Our Ref: Z20301  
Your Ref: DA23/0316  
LN33816  
Andrew Watkins

**23 July 2024**

**RESPONSE TO ASSESSMENT MANAGER'S INFORMATION REQUEST  
DEVELOPMENT APPLICATION FOR PROPOSED PLACE OF PUBLIC WORSHIP + ANCILLARY OFFICE,  
COMMUNITY MEETING ROOM, WEDDING CHAPEL & A RESTAURANT OR CAFÉ AT  
90 PHILLIP STREET, CHINDERAH  
(LOT 12 DP830660)**

**Figure 1** Proposed earthworks - 50 m CWA buffer red

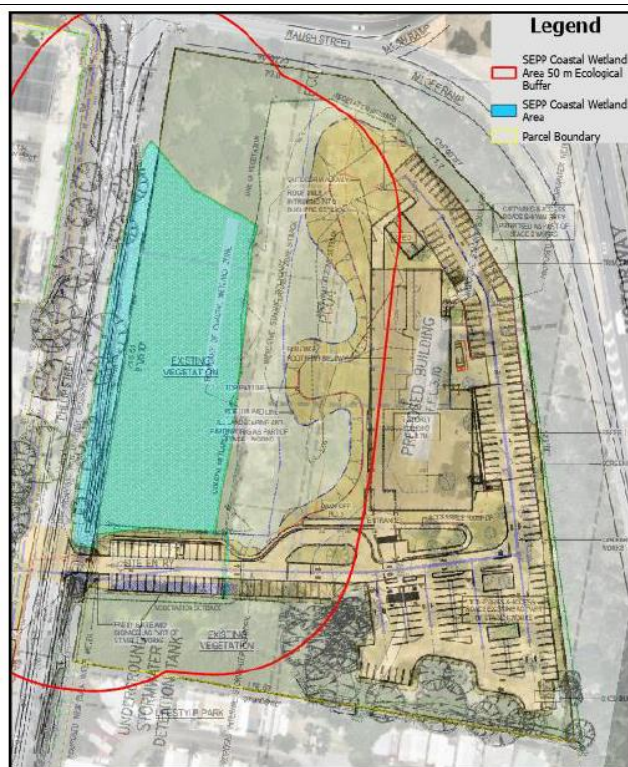
- Proposed car parking and pedestrian access immediately adjacent to the Coastal Wetland Area (CWA) (north) and candidate Endangered Ecological Community (EEC) upon entry to the site. Negligible setbacks are provided.*

- Proposed filling to the east of the site within approximately 17 metres of the CWA and immediately adjacent to a candidate EEC to the north of the site.*

*The extent of proposed filling and built form development encroachment into the 50 metre Coastal Wetland Area ecological buffer is depicted in Figure 1 and Figure 2 respectively (see below/following page):*

- i. Car parking areas immediately north and south adjacent of the entry driveway have been removed as requested;
- ii. Fill material within the conservation footprint has been generally removed as requested, though we note the car parking footprint has marginally changed; and
- iii. Civil Engineering detail confirms no development occurs or extends within the Coastal Wetland Area.

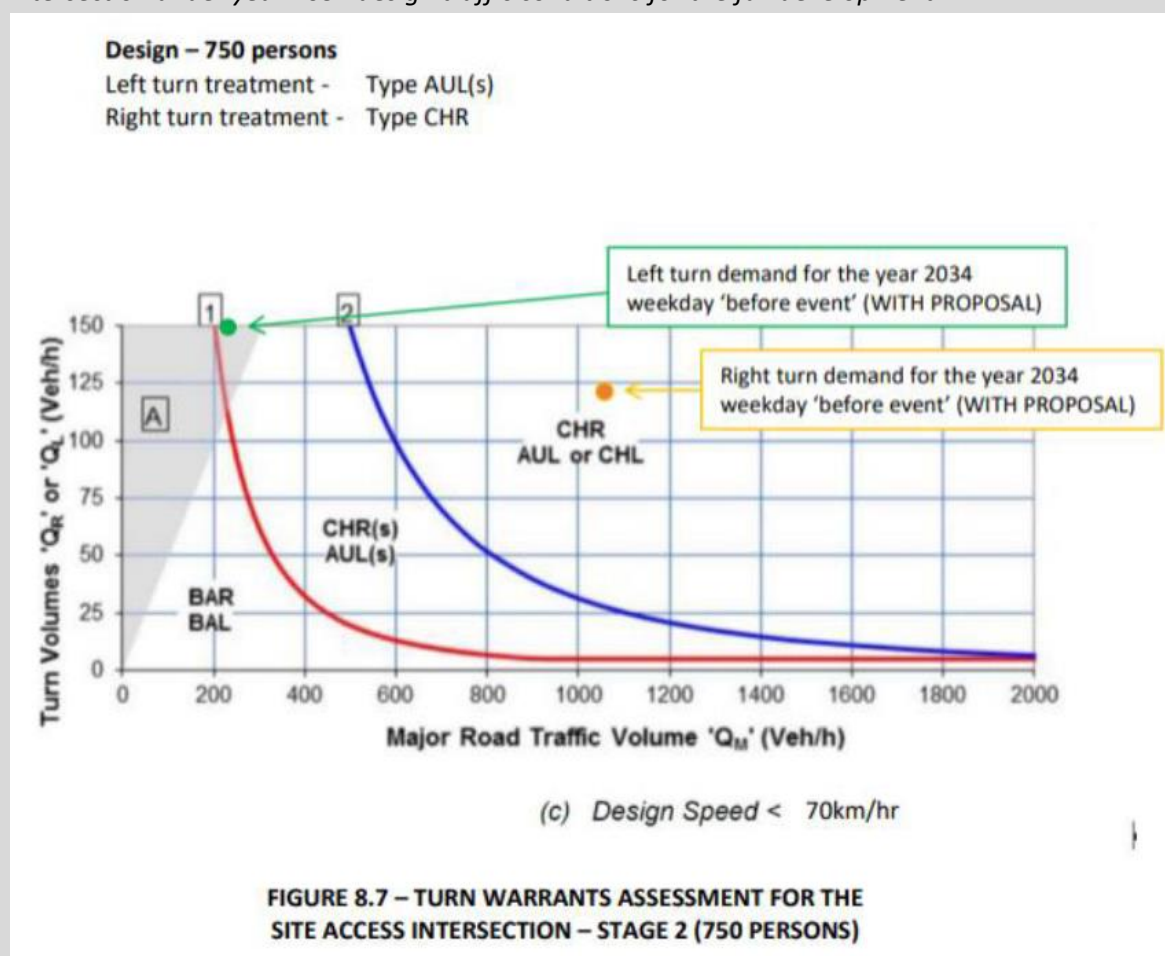
*Removal of all carparking/hardstand areas from the indicative 'Conservation Footprint' referred to above, will result in a parking shortfall of 33 car parking spaces in relation to the requirements of Section A2 Site Access and Parking of Council's DCP, which is not considered acceptable.*

*The proposed development should be revised so that proposed parking complies with the requirements of Section A2 of the DCP.*

Through the removal and reworking of parking areas, the proposal results in a marginal reduction to overall parking of two (2) spaces. Simultaneously, a minor rework of the internal areas has been undertaken to reduce the operational capacity of the church from 750 to 710, which in turn ensures the proposal remains compliant with Council parking provisions in any event.
